## Planning Commission Vote Report

**Petition:** **PZ 20-2019 Briarcliffe Villas (14001 Olive Blvd):** A request for a change in zoning from R-3 Residence District to PUD Planned Unit Development for a maximum of 117 residential units (16R340151).

Re: P.Z. 19-2019 & P.Z. 20-2019 Briarcliffe Villas, Response Letter (Stock Project No. 219-6568)

SHEET NO.:  
**C1.0**

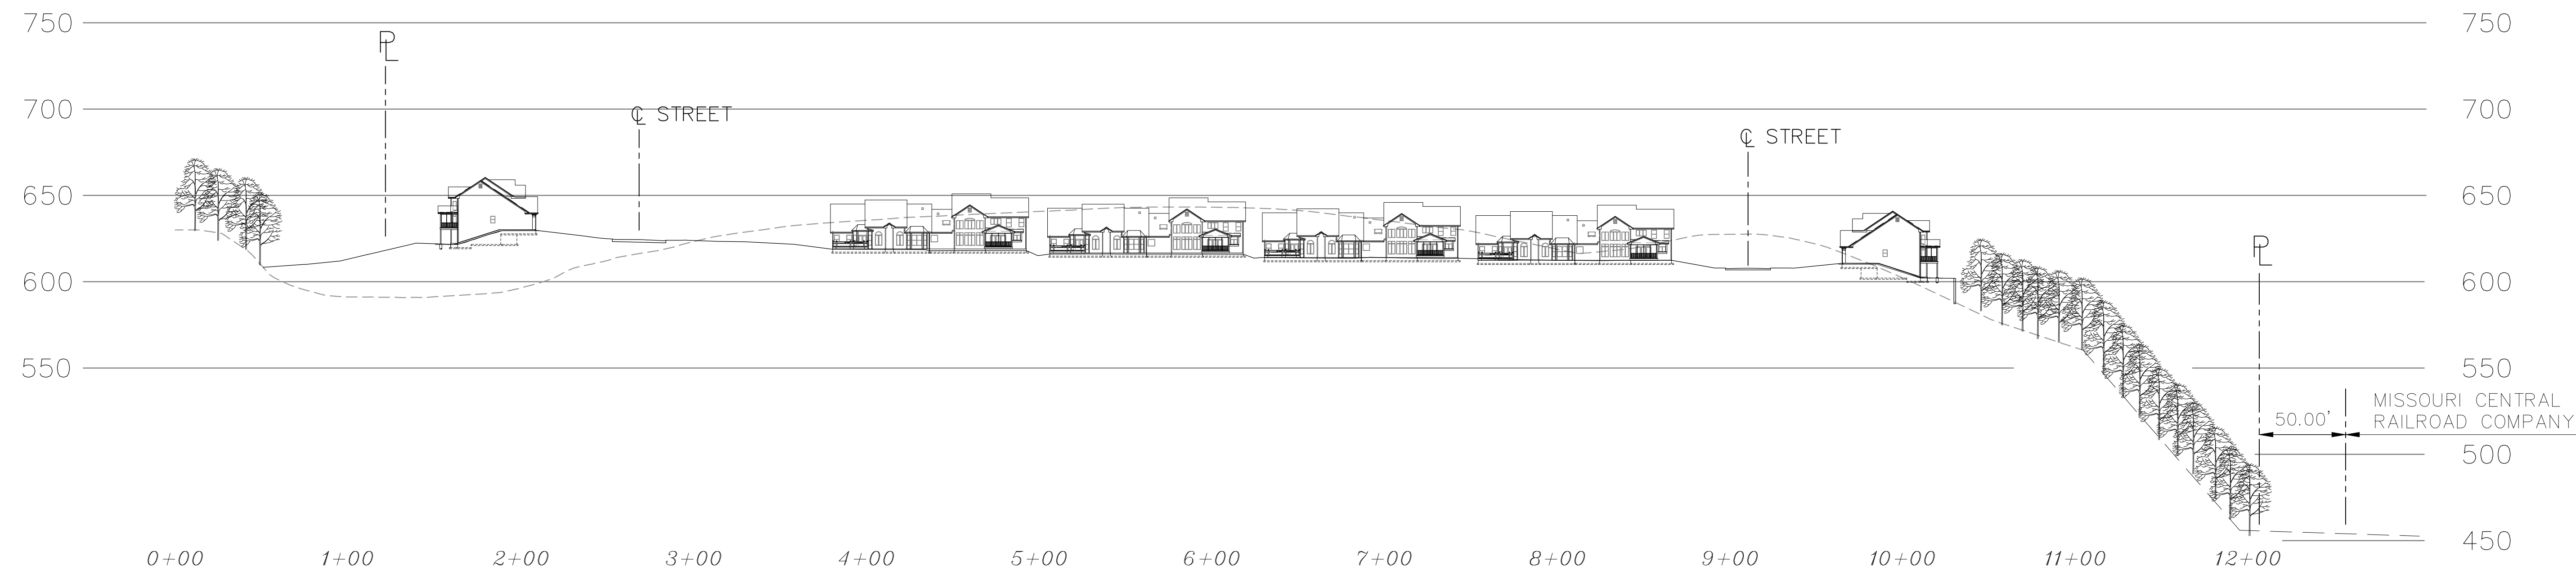
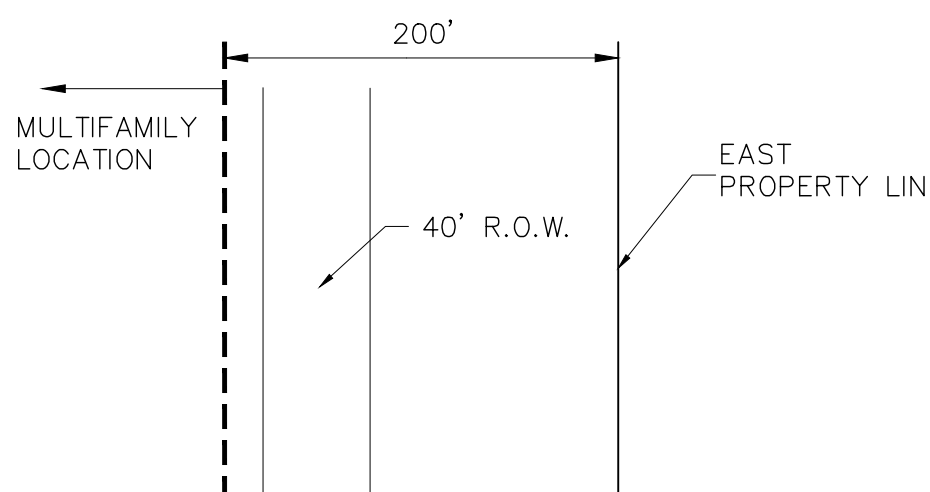
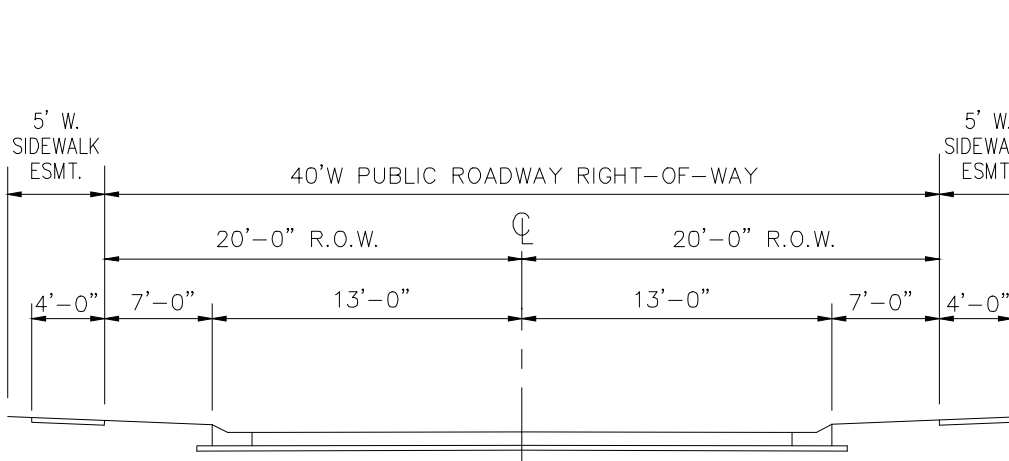
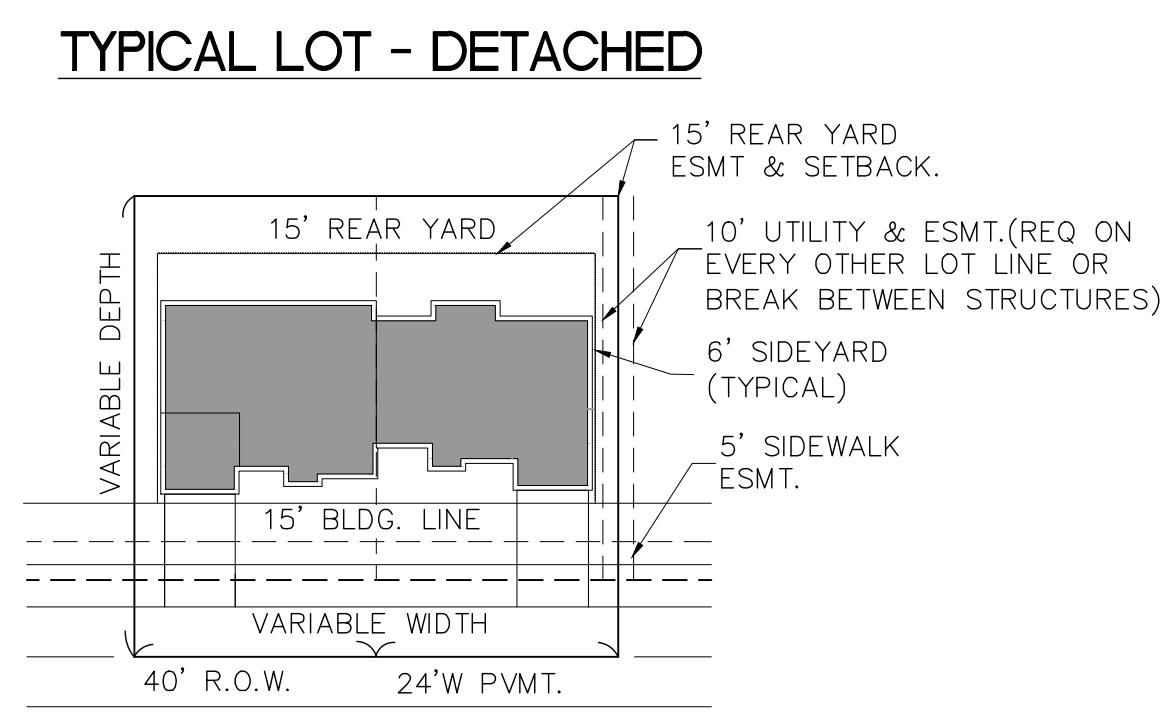
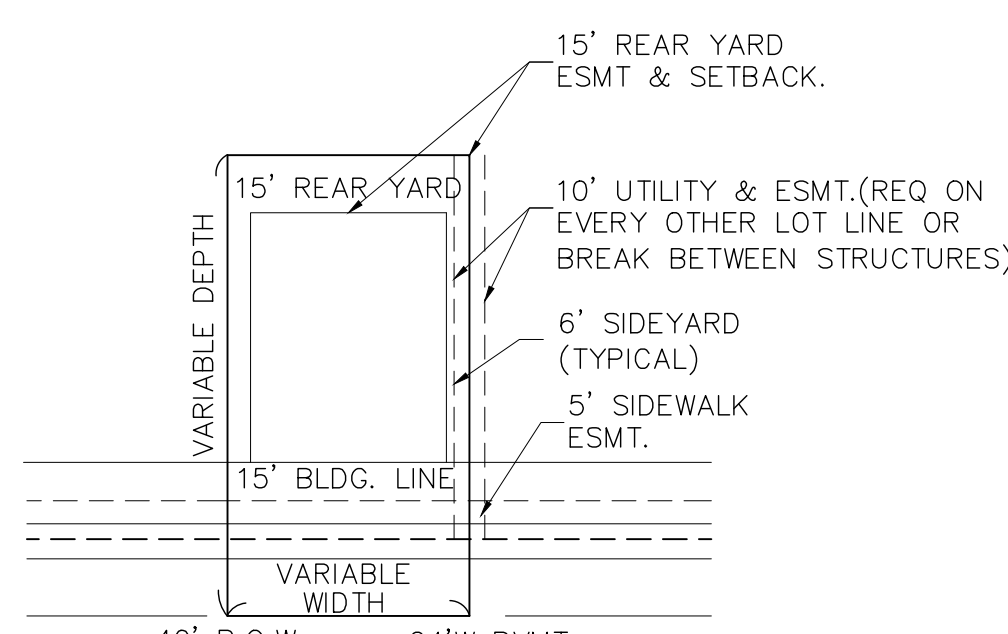
2. Show the limits of the depicted Common Ground areas, specifically regarding the common ground by the entrance off of Olive Boulevard.

3. Revise the note by the 200' setback line to reflect multifamily rather than condominiums.

**Response:** Information added to the Preliminary Plan.

**Response:** Information added to the Preliminary Plan.
